**Addendum (Revision 1) to Remedial Action Options Report (RAOR)  
and Pre-Design Sampling Work Plan - Connell Aluminum Properties, LLC  
Former Koppers Tar Plant and Wabash Alloys Site  
9100 S. 5<sup>th</sup> Avenue, Oak Creek, WI 53154  
BRRTS# 02-41-553761, FID#241379050  
Connell VPLE BRRTS #:06-41-560068**

January 11, 2021

**City of Oak Creek Utility Corridor Lot 1  
9170 South 5<sup>th</sup> Avenue, Oak Creek, WI 53154  
BRRTS#: 02-41-561425, FID #:341074470  
VPLE BRRTS#: 06-41-561426**

This Addendum (R1) letter addresses the WDNR's comment letter dated October 25, 2017 and the additional June 10, 2020 comment letter provided to Connell upon WDNR's review of the March 13, 2020 Addendum regarding *Review of Site Investigation and Remedial Action Options Reports, Former Koppers Tar Plant and Wabash Alloys Facility*. On July 7, 2020, Connell participated in a conference call with the WDNR in which we discussed our proposal for revising the Addendum to address the WDNR's June 2020 comments. We discussed increasing the cap extents in several areas to closely match the extents planned by Beazer for capping the creosote-impacted (PAHs) soil, for which WDNR did not have an objec

PROJECT NO.  
 2095/6.1  
 FIGURE NO.  
 C4

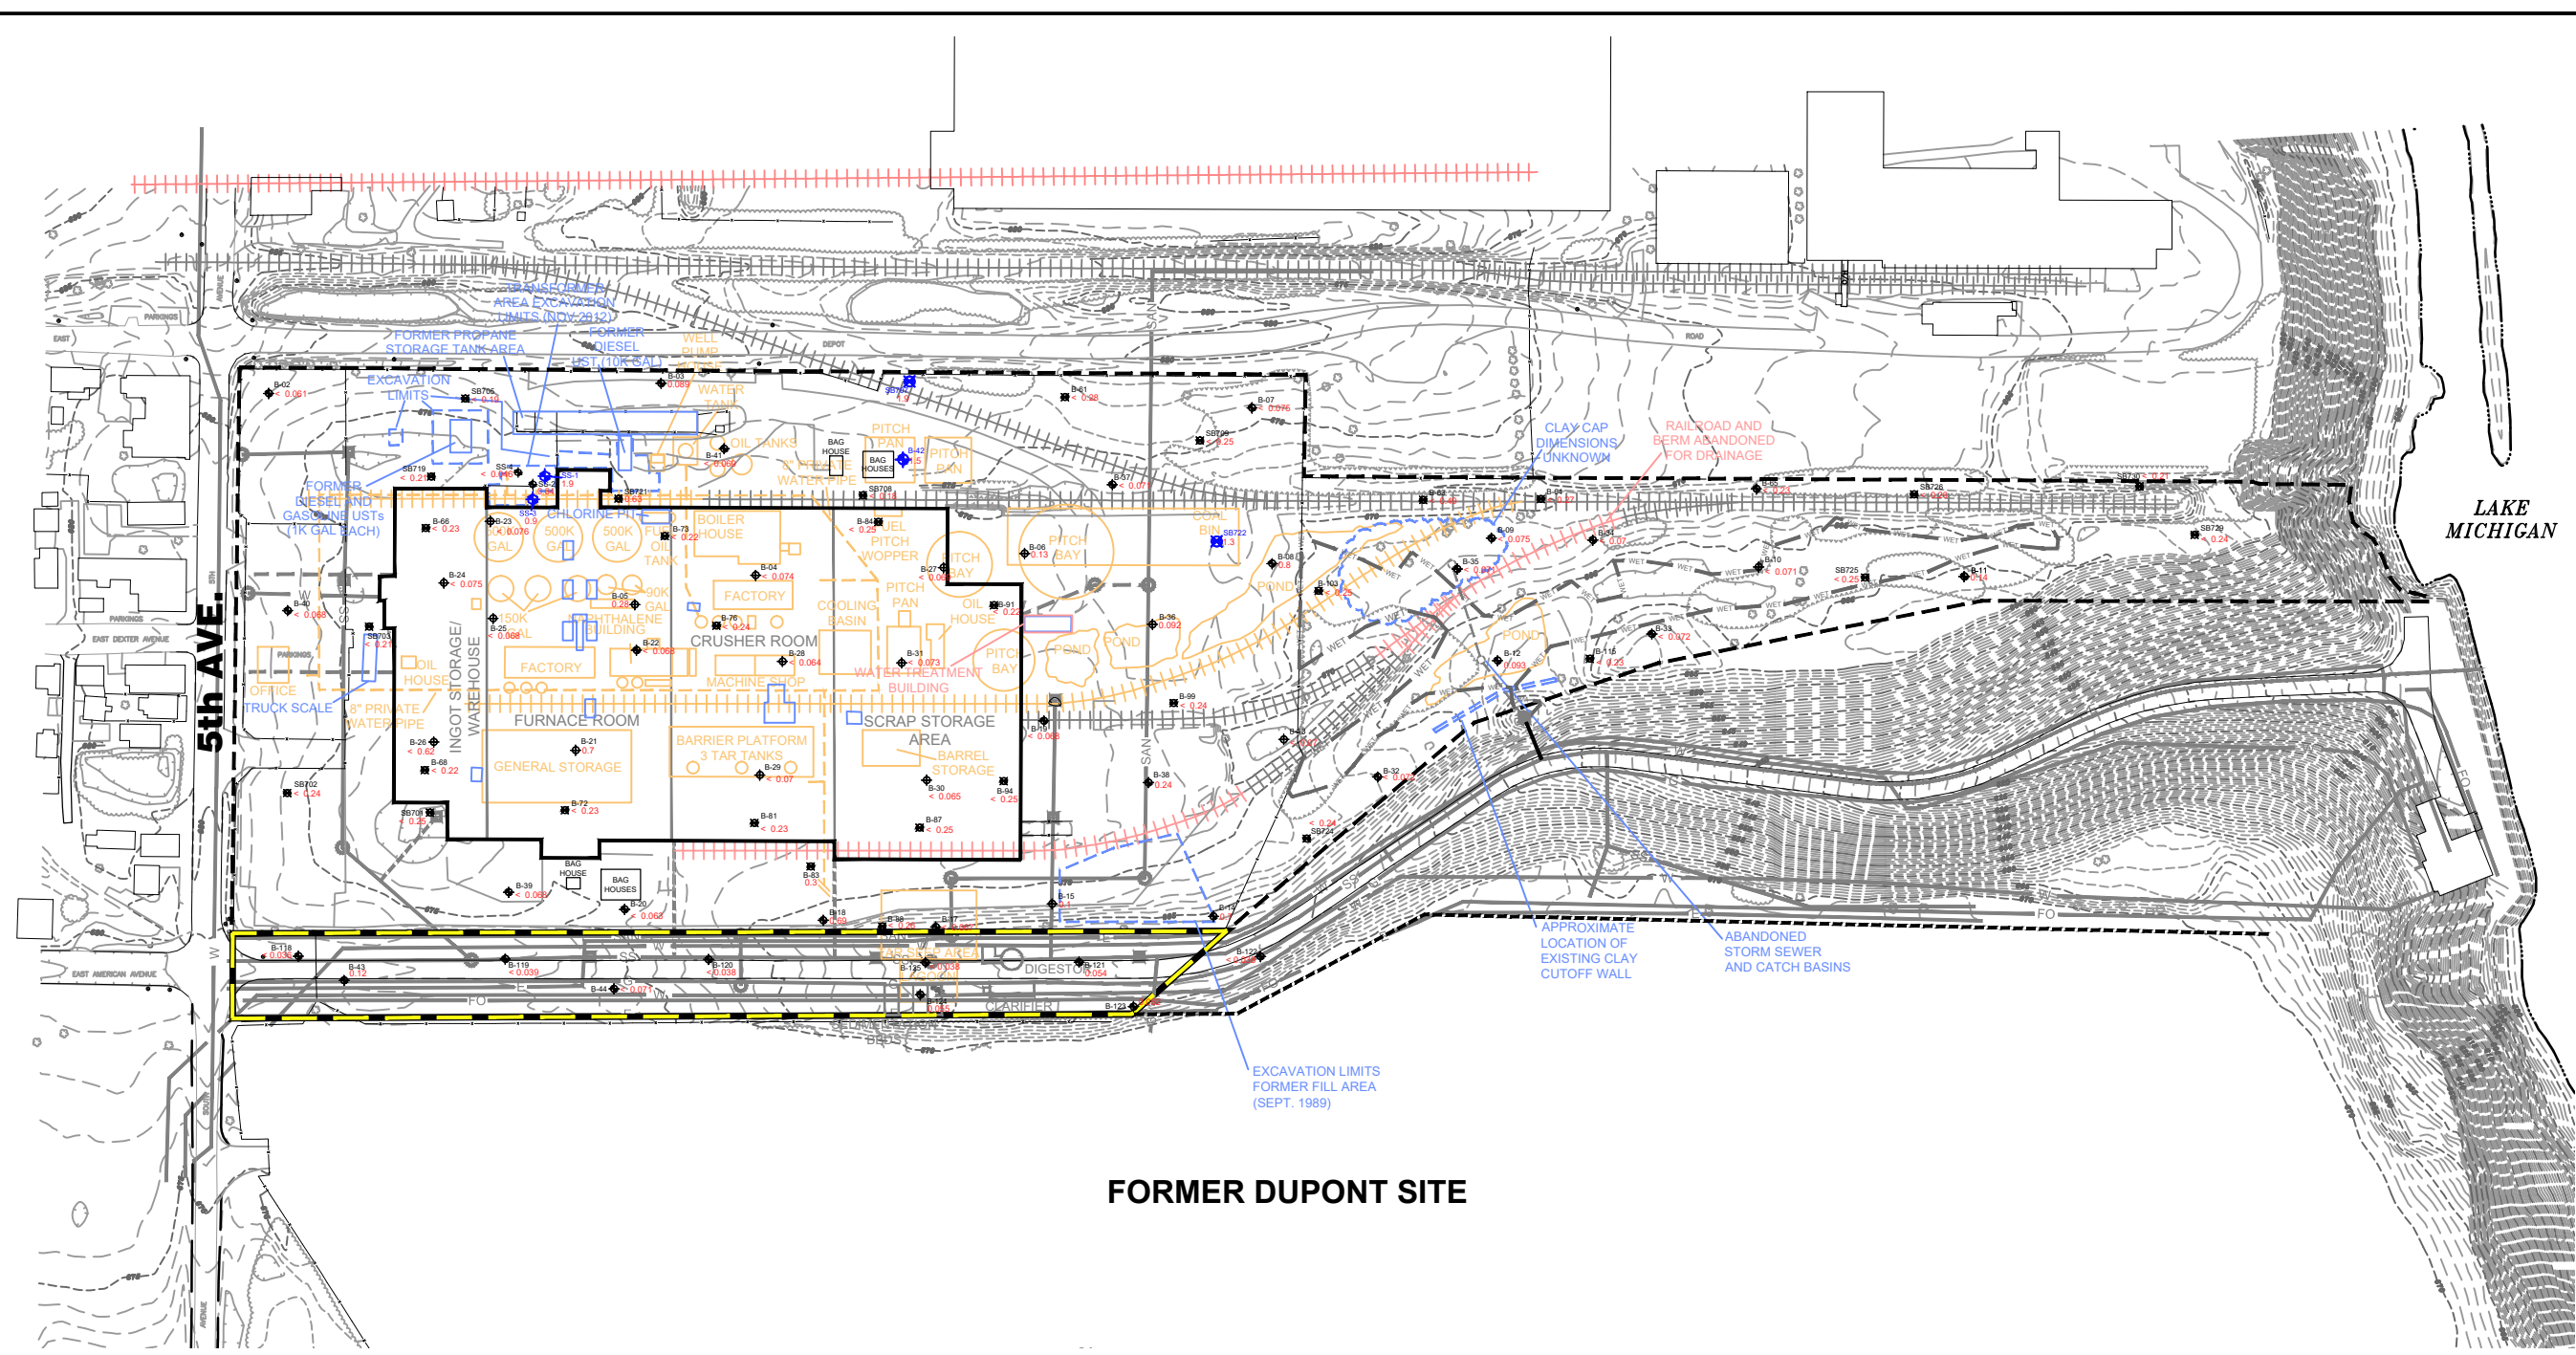
On January 27, 2014, NRT resubmitted the SI Report Figures C4 (Chromium, 0-4 ft bgs) and C8 (Silver, 0-4 ft bgs) after realizing an error on the figures that did not match the tables for chromium and silver (NRT transmittal dated January 27, 2014 is attached). Note that the data for B-08 has been corrected on these figures and are attached.

Eric – Attached are 3 hard copies of the revised figures and 3 full report CDs for the Site Investigation Report (VPLE BRRTS Activity #06-41-560068). As I mentioned over the phone, we made edits to Figures C4 and C8 and are providing updated versions. You may recycle the current Figures C4 and C8 and the CDs provided with each report. If you have any questions, please let me know.
